M E M O R A N D U M

TO: Casey Adragna, Adragna Architecture
FROM: Elizabeth Steward, Associate Planner- Development Review
DATE: 6/18/26
SUBJECT: Douglas 234 Multitenant, Site Plan
Review Comments 04

LOT 10B, DOUGLAS 234 FILING NO. 6, AMENDMENT 2
HORSE CREEK COMMERCIAL SITE PLAN
LOCATED IN THE SW 1/4, SE 1/4, SECTION 29, T6S, R66W, 6TH P.M.
TOWN OF PARKER, COUNTY OF DOUGLAS, STATE OF COLORADO
PAGE 1 OF 15

COVER SHEET
LOT 10B, DOUGLAS 234 FILING NO. 6, AMD. 2
JOB NO. 24020
DATE: JUNE 2, 2026
SHEET C1

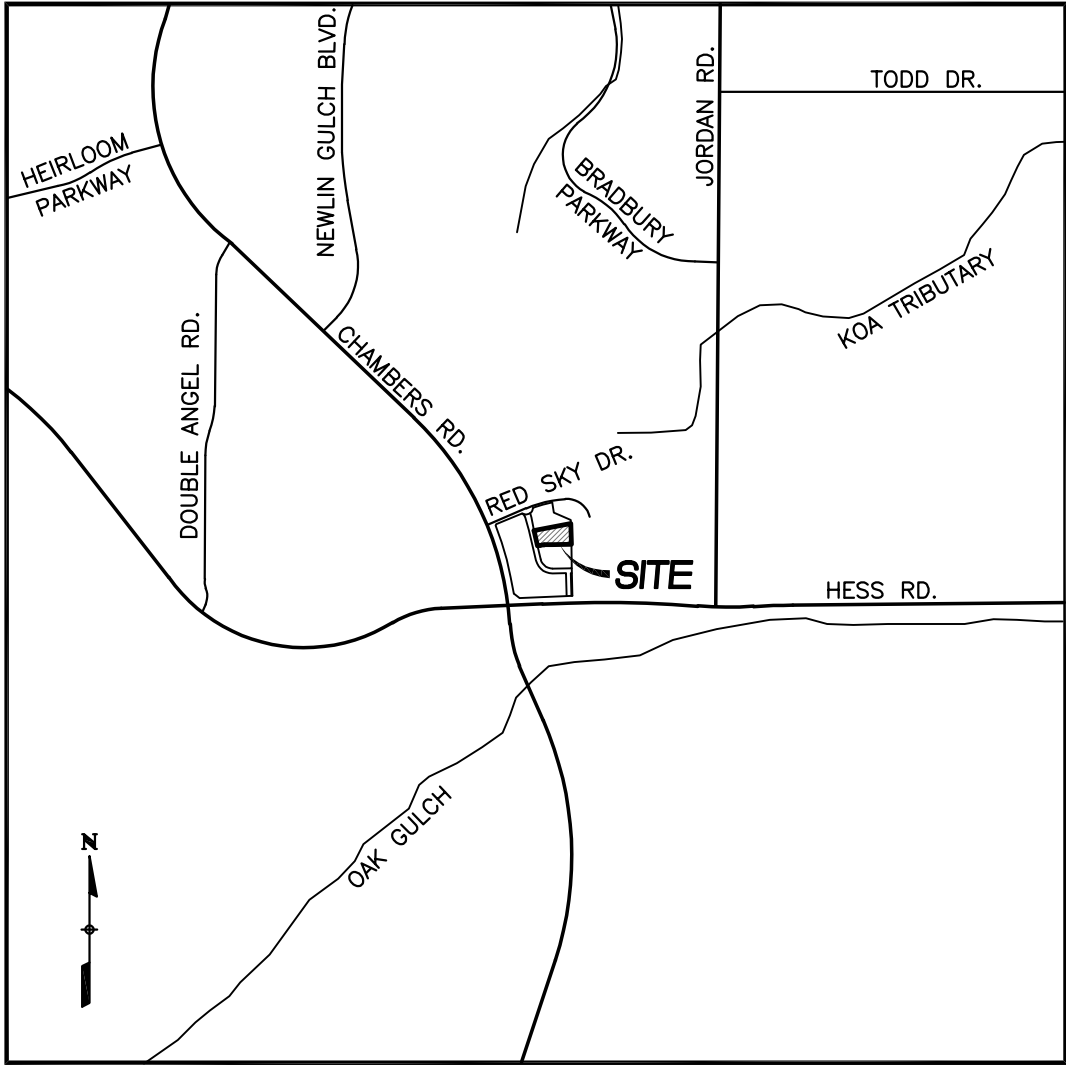
most uses, including general retail, medical clinic, personal studio and services and office uses require 1 space per 300 SF NLA. At 15,877 to park each tenant for any of these uses 53 spaces would be required. You are currently providing 53 spaces, please update the required ration to 1 space/ 300 SF NLA to allow as many uses as possible.

revised to 1/300

LOT 10B, DOUGLAS 234 FILING NO. 6, AMENDMENT 2
HORSE CREEK COMMERCIAL SITE PLAN
LOCATED IN THE SW 1/4, SE 1/4, SECTION 29, T6S, R66W, 6TH P.M.
TOWN OF PARKER, COUNTY OF DOUGLAS, STATE OF COLORADO
PAGE 3 OF 15

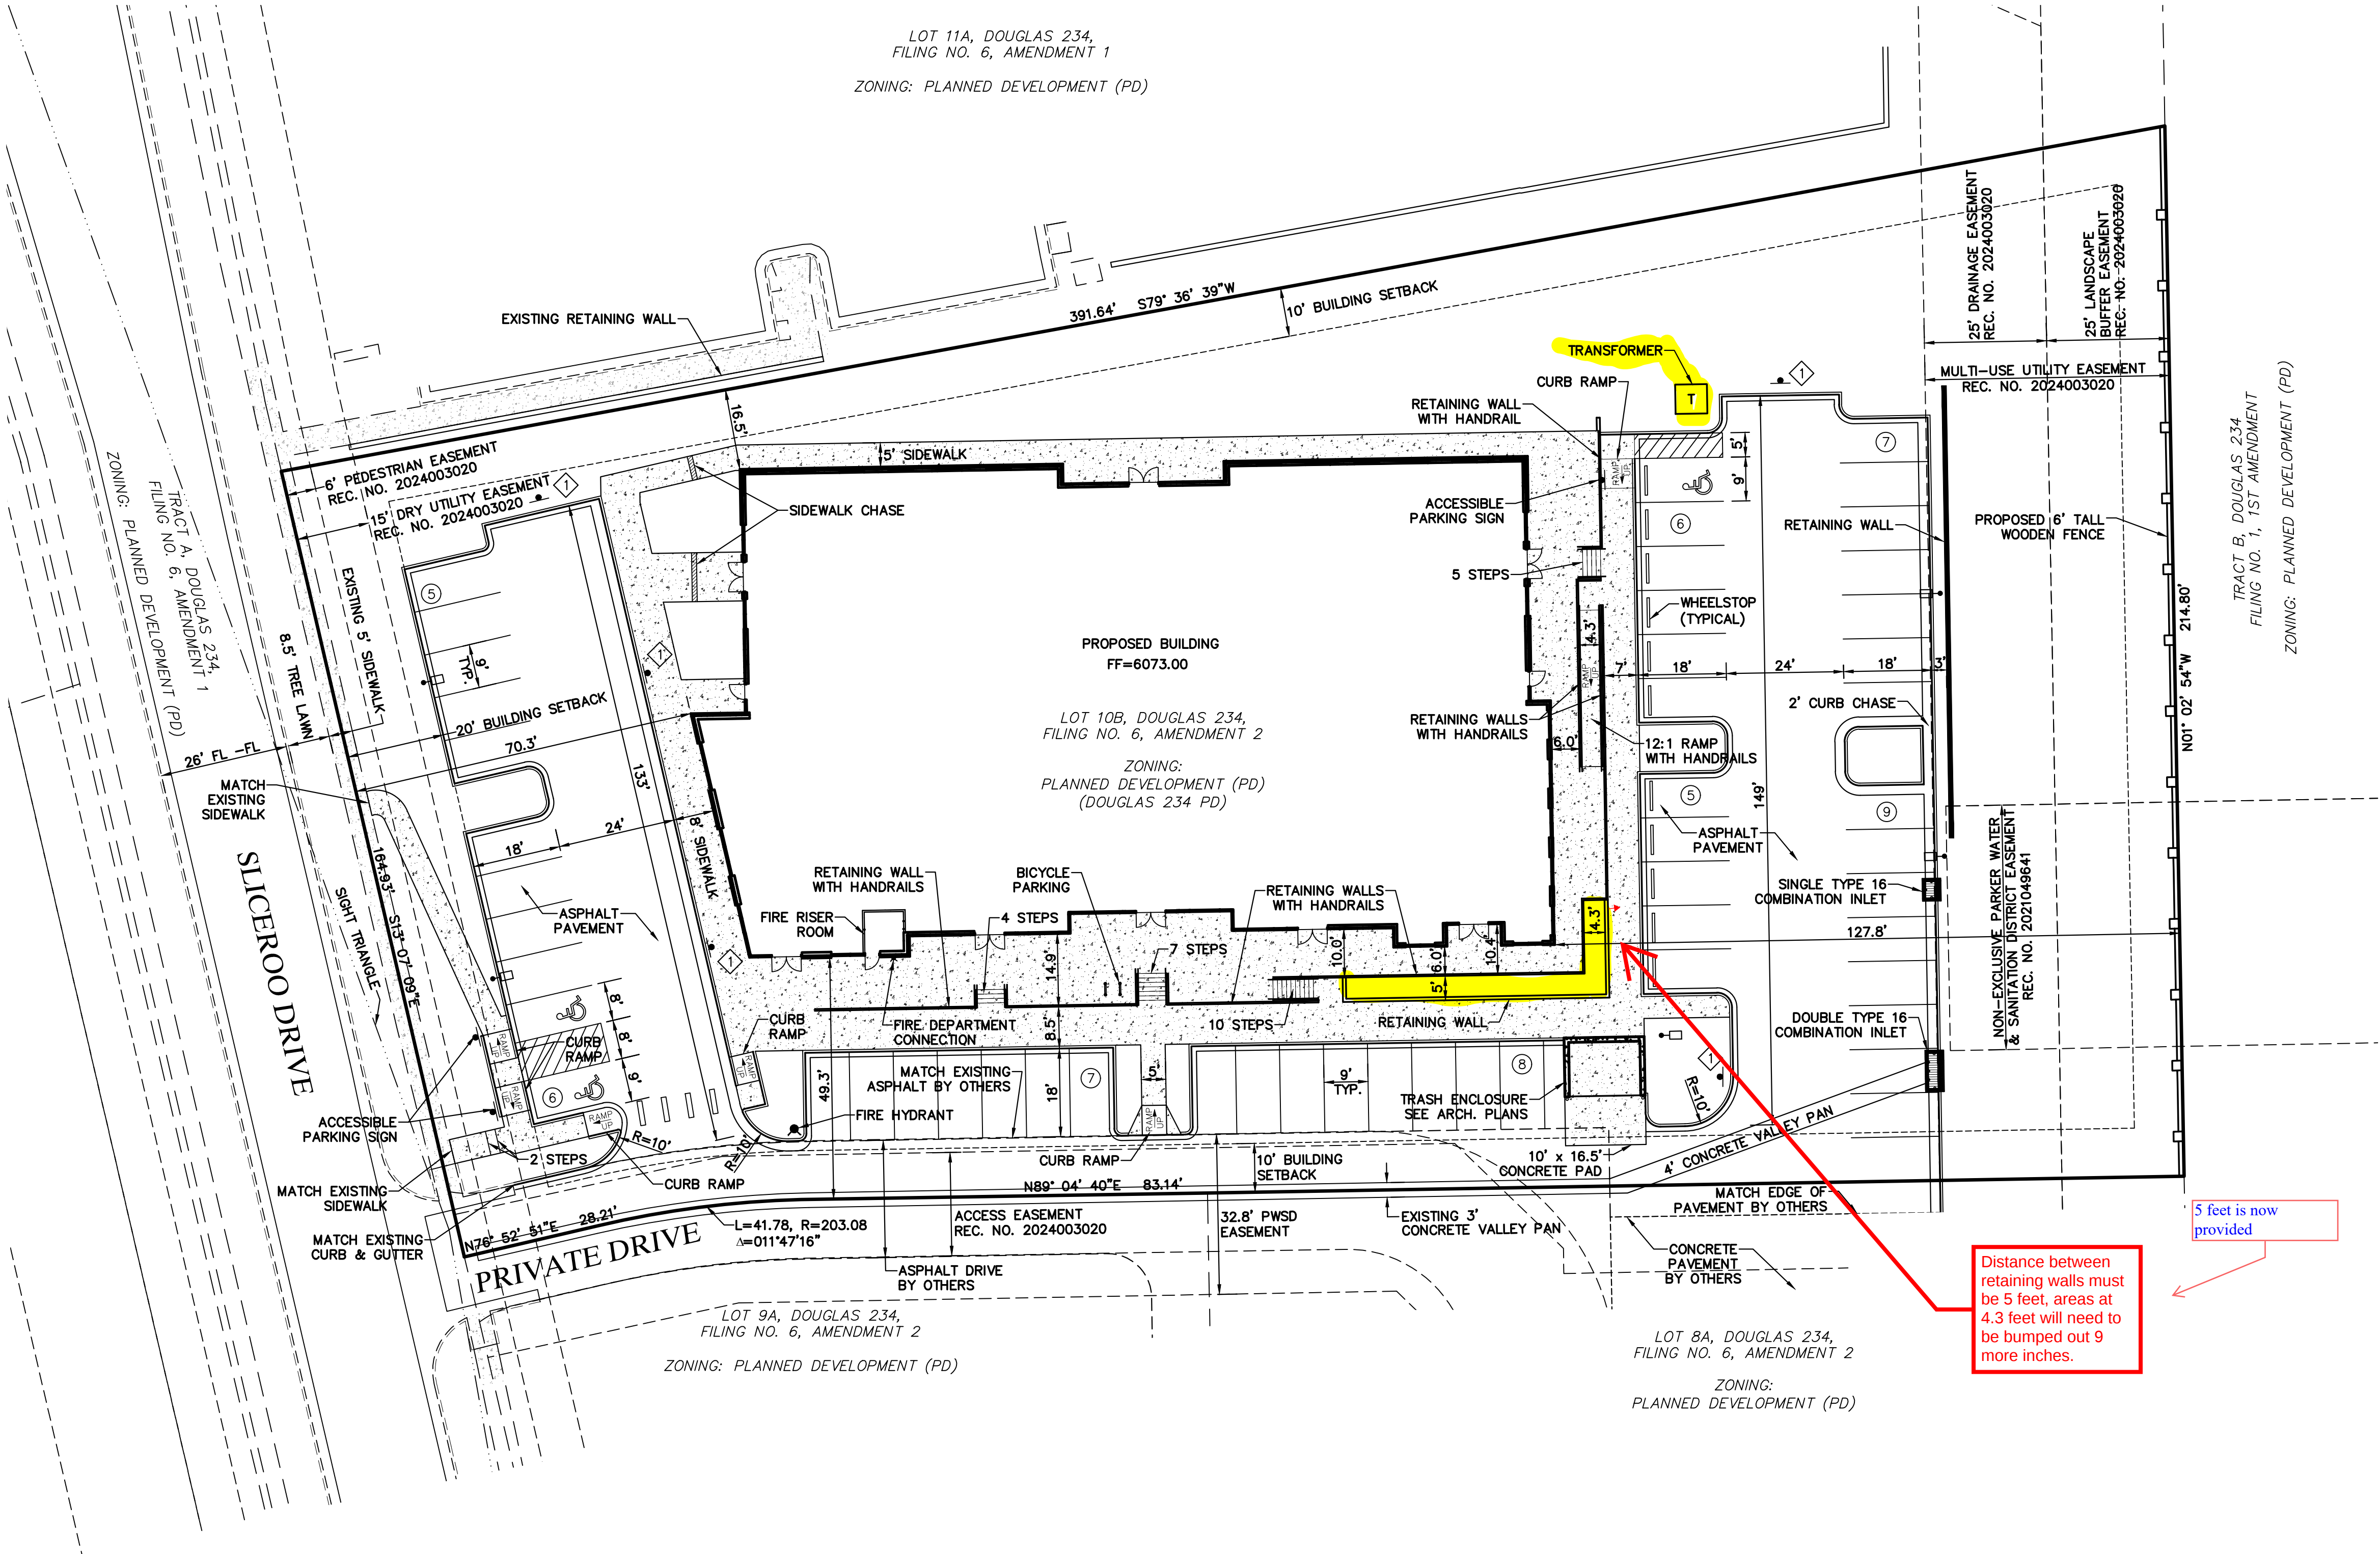
Distance between retaining walls must be 5 feet, areas at 4.3 feet will need to be bumped out 9 more inches.

5 feet is now provided

LANDSCAPE PLAN
LOT 10B, DOUGLAS 234 FILING NO. 6, AMD. 2
JOB NO. 24020
DATE: JUNE 2, 2026
SHEET L1

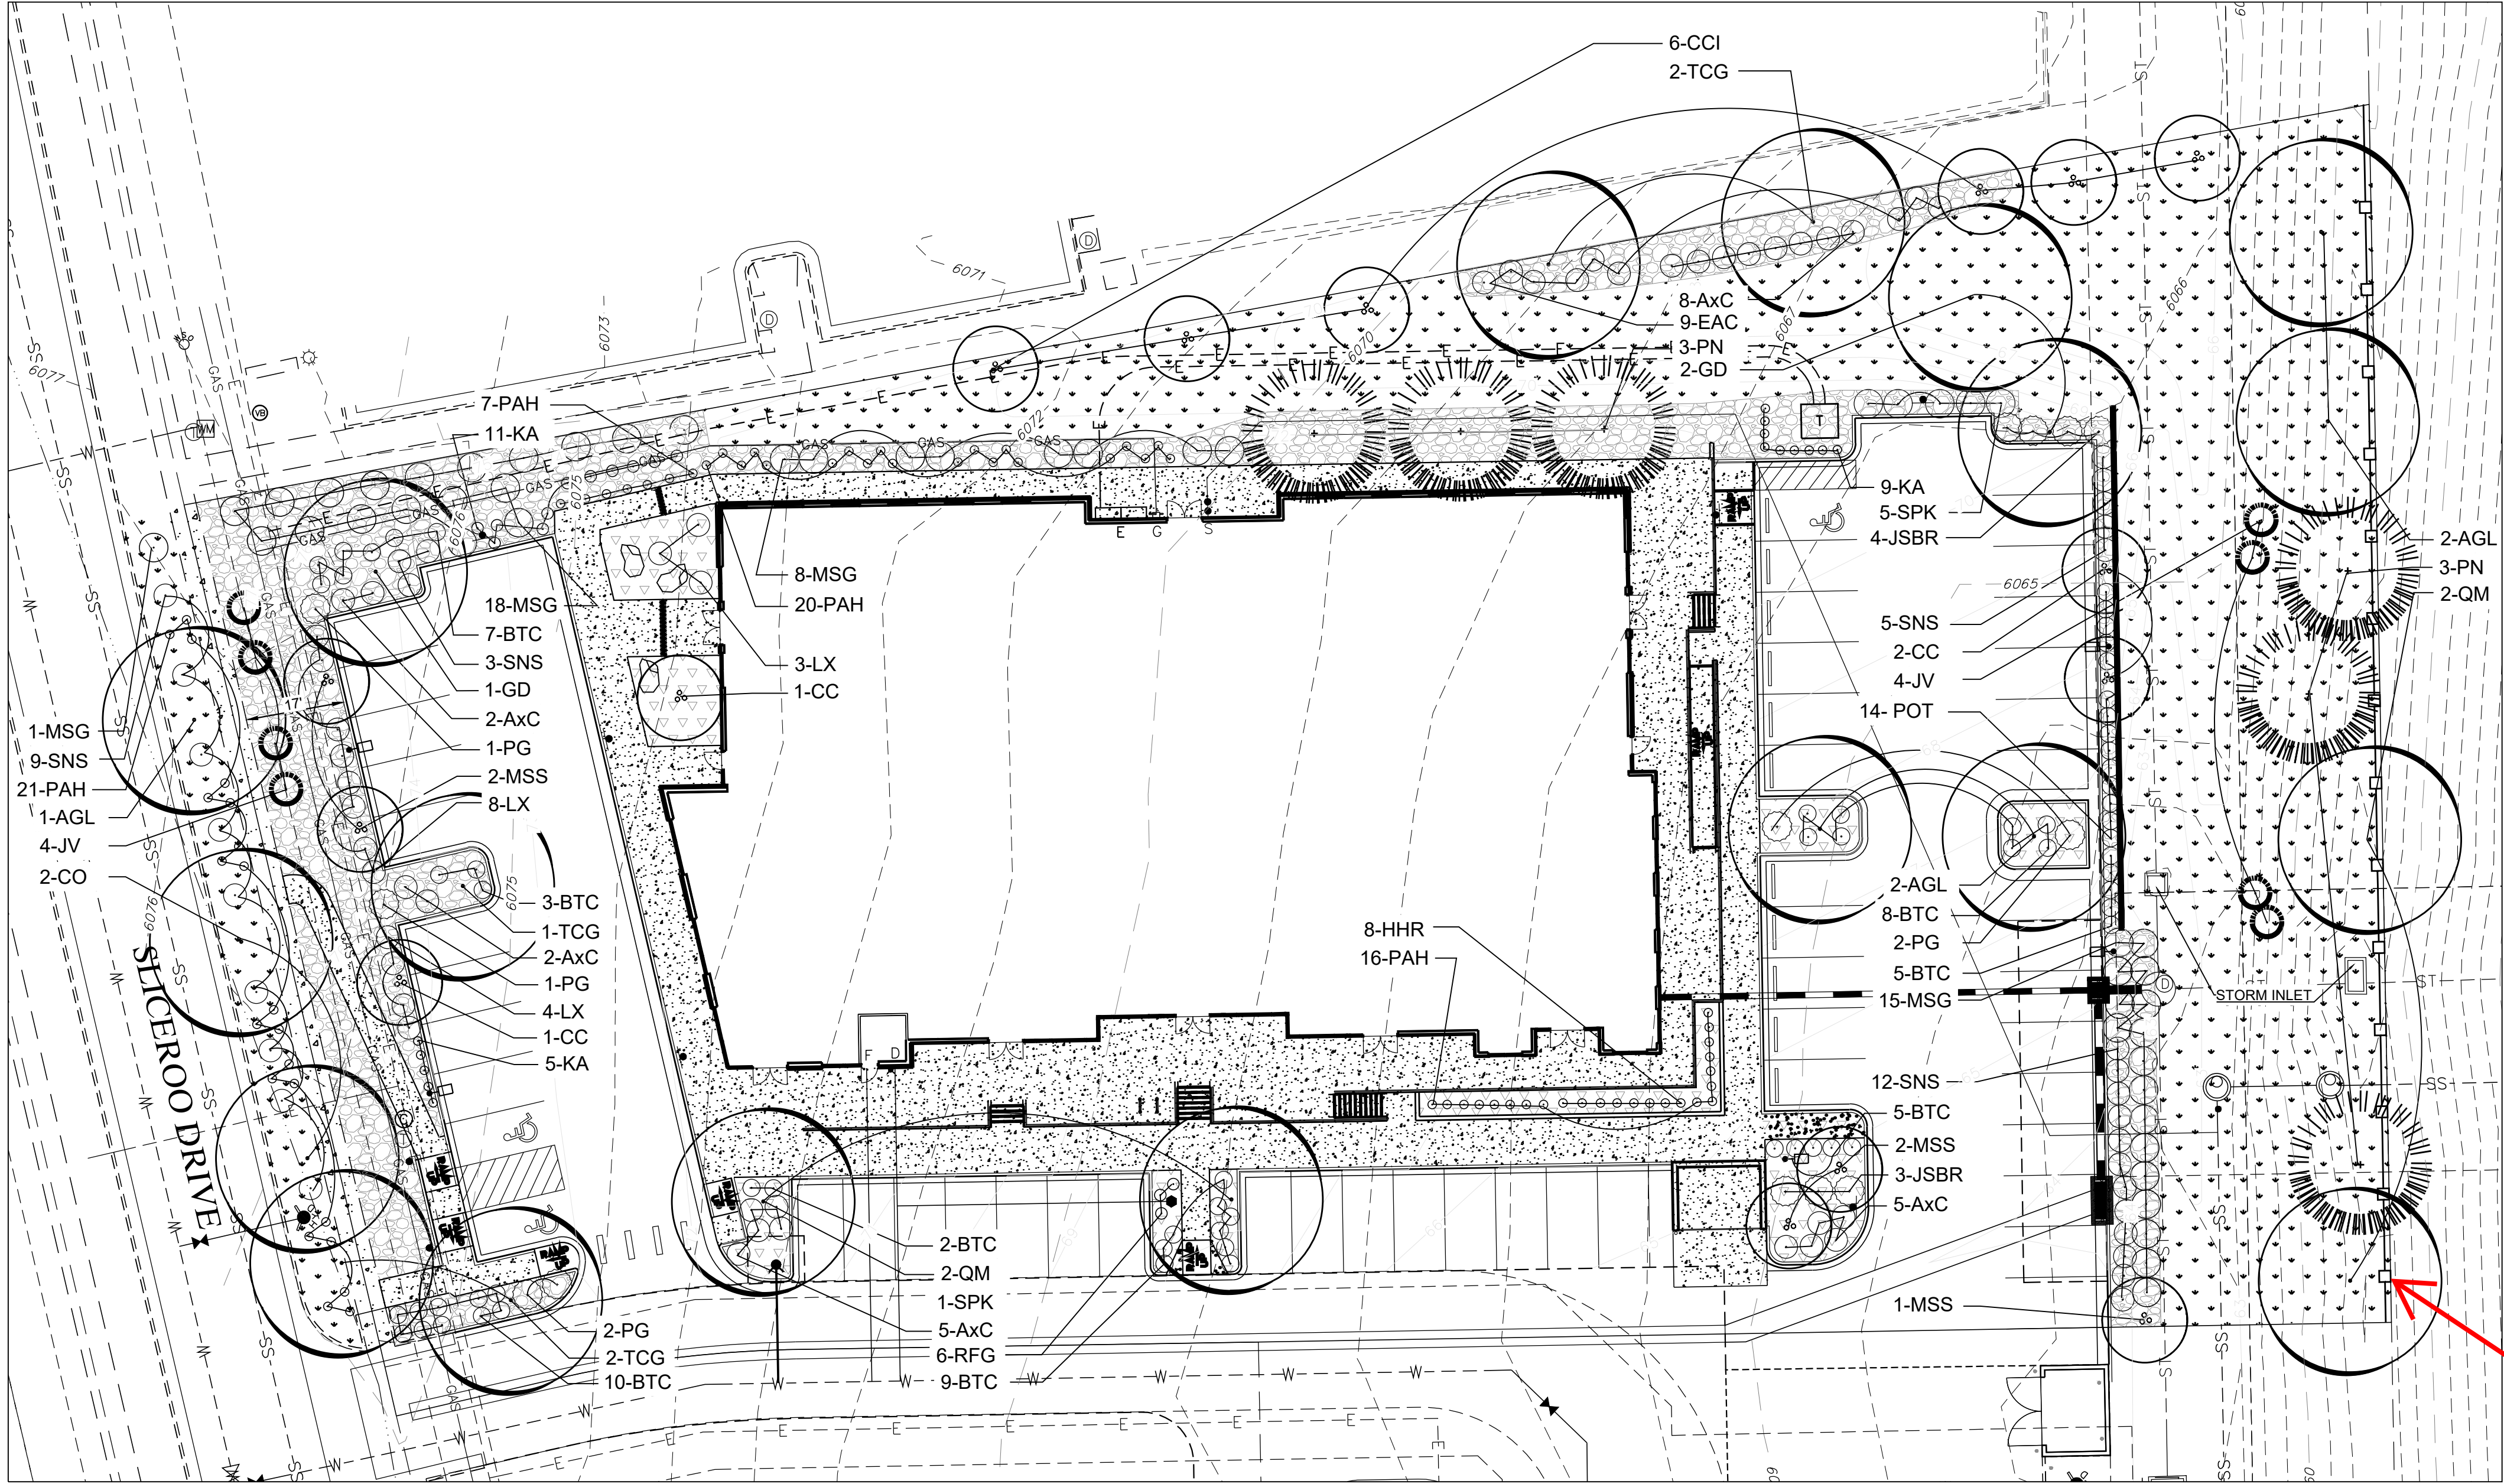
Please label the
fence location and
maximum height
(allowed only up to 6
feet)

FENCE LABEL
ADDED

CEDAR PRIVACY FENCE

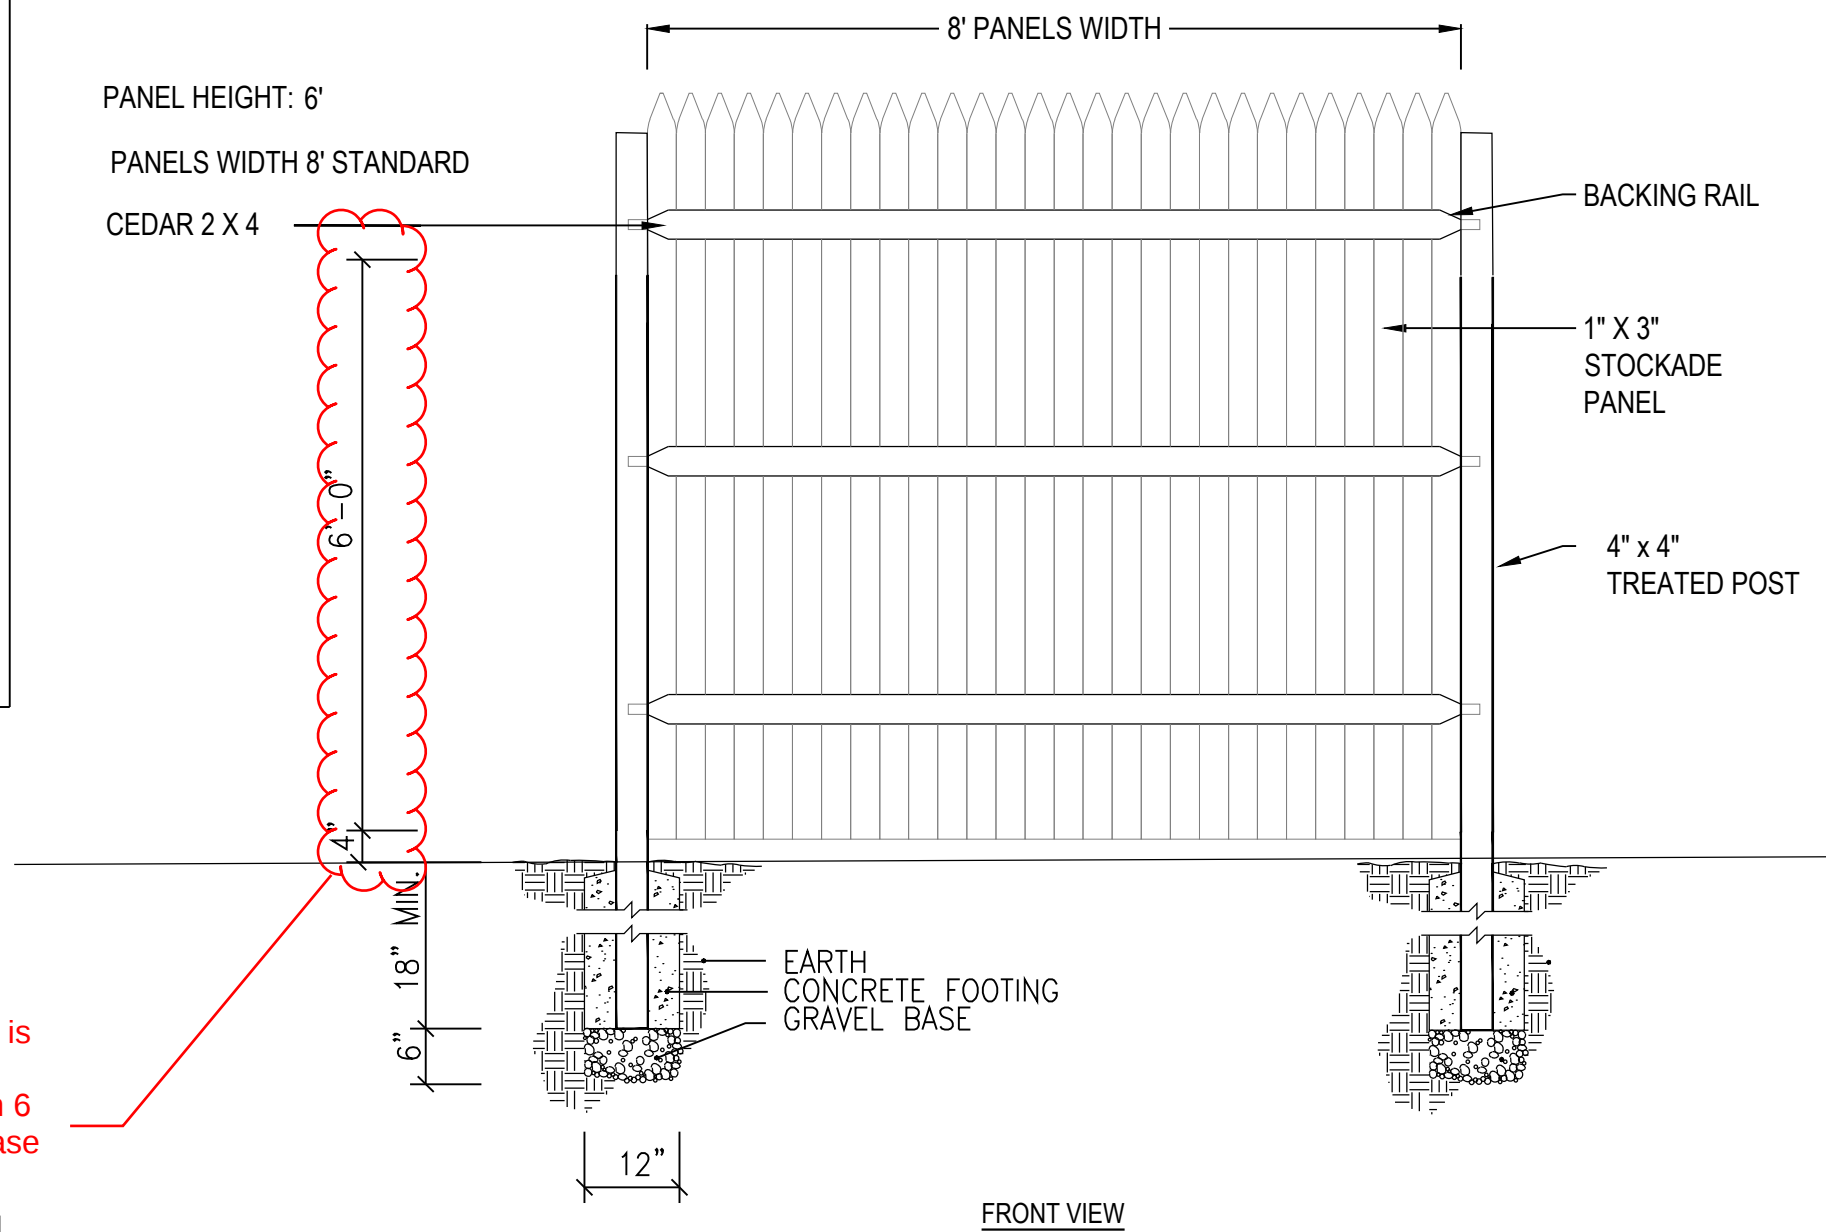
this measurement is implying that the fence is taller than 6 feet in height, please confirm the total fence height.

DIMENSION LINE
REVISED
